Registration Date:	28 November 2024	Application No:	P/01272/024
Officer:	Martin Cowie	Ward:	Langley St. Marys
Applicant:	C/O Agent, Redsky Willow Tree Ltd.	Application Type:	Major
Agent:	Eleanor Cannon, Savills, 33 Margaret Street, London, W1G 0JD		
Location:	Former Willow Tree Public House, 62 Station Road, Langley, Slough, SL3 8BT		
Proposal:	Retrospective application for a part 1, part-2, part-3, part-4 and part 5-storey building containing 51 flats (Use Class C3) together with associated lift overrun and roof access, refuse storage, cycle parking and landscaping works. Additional works are also proposed including the installation of cycle storage, green roof, photovoltaic panels, electric charging infrastructure, a door to replace window on southern elevation of refuse store and further landscaping works.

Summary of Recommendation: Delegate to Planning Manager for Refusal

Photo showing western elevation of building overlooking neighbouring houses

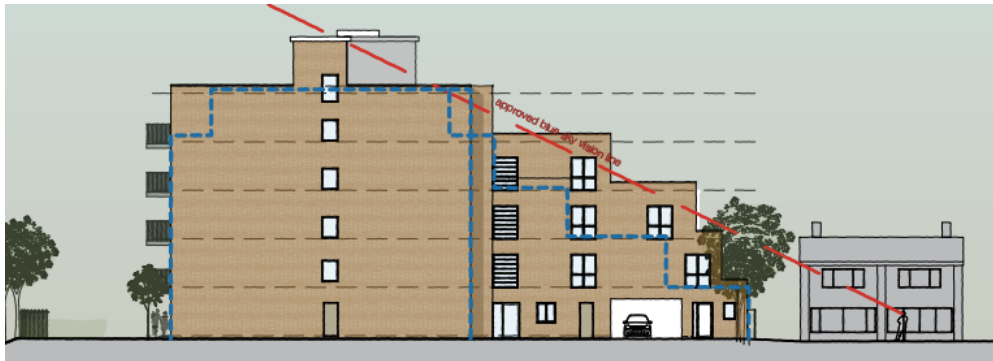
- 15.6 Whilst the Inspector considered the proposal would adversely affect the living conditions of the neighbouring occupiers of No's. 117 and 119 in relation to privacy, given this affected garden areas rather than the internal spaces and the proposed obscure glazing and boundary trees would restrict views, attributed limited weight to the conflict with local policy.
- 15.7 The development as-built presents a larger building to the rear of the neighbouring houses and their gardens than those consented. The main part of the building is approximately 15/16m high, effectively extends the full depth of the site and sits approximately 17m from the side boundary of the nearest neighbour at No's. 119 Alderbury Road. As-built development shows the real effects and impact experienced by the residents.

- 15.8 The extended top floor and increased massing on Alderbury Road effectively serve to further enclose the space between the building and the back of the adjoining properties. This relationship is considered to be visually overbearing and detrimental to the residential amenity of those nearest occupiers at No's. 117 and 119. As the Inspector noted on appeal, the uppermost storey of the proposed scheme would be recessed such that it would soften the massing and reduce the impact of the top storey.
